RE: JMC Project 15137  
Greens Farms Plaza  
1460 Post Road East  
Westport, CT 06880

**Tree Board Review Comment Response**

**Southeast Corner**

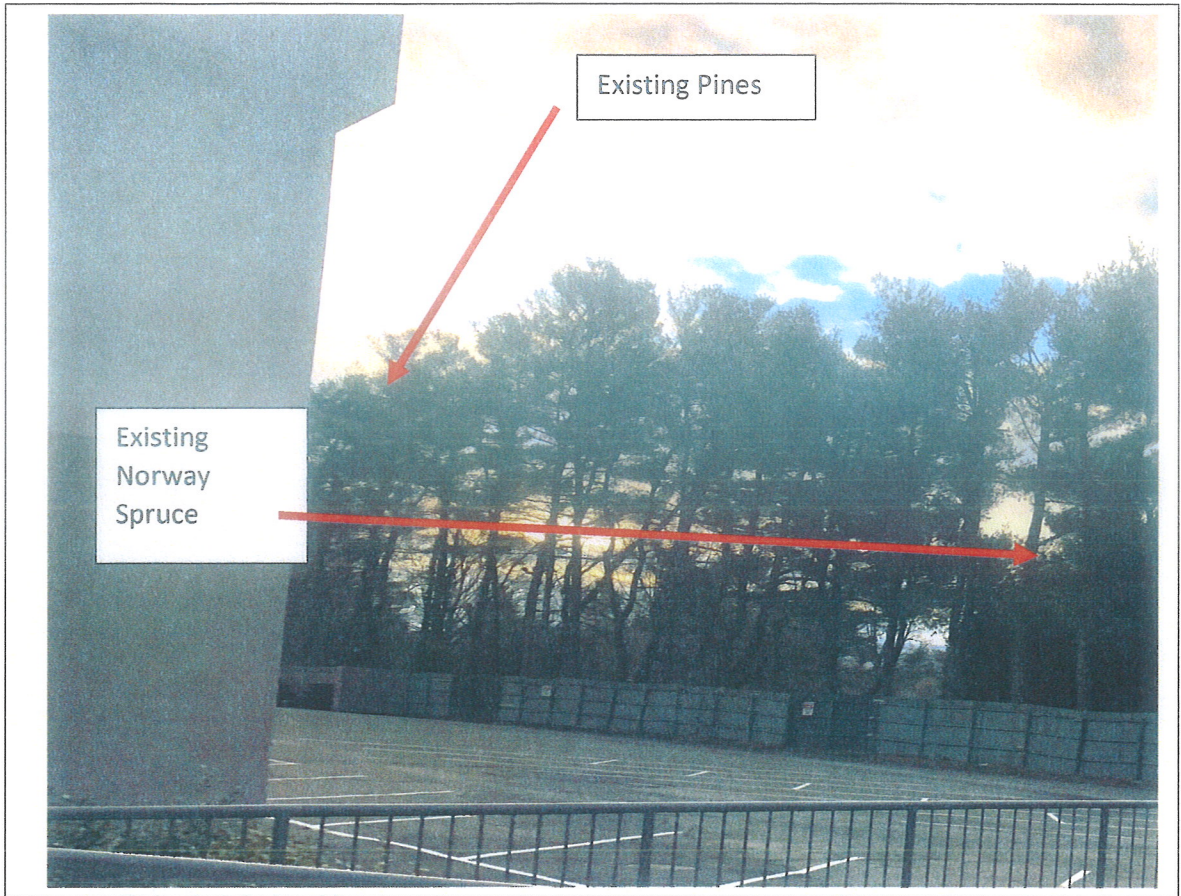
*No or useless evergreen buffer screening. Only ½ of buffer strip has older White Pines which are very tall with no lower branches. While white pines are not allowed to be used as screening plants. They are subject to storm damage and wind breakage. This is a plant that only gets worse not better. New screening evergreens could be Arborvite 'Green Giant' or Norway Spruce 8' – 10' ht. @ 10' O.C.*

- **Southeast Corner of the Site** – This area includes the existing trash enclosures that area currently screened by an 8-foot solid privacy fencing. The revised plan includes landscaping at the container storage of (6) Arborvitae 'Green Giant' proposed at 6' – 8' ht. See photo on next page.
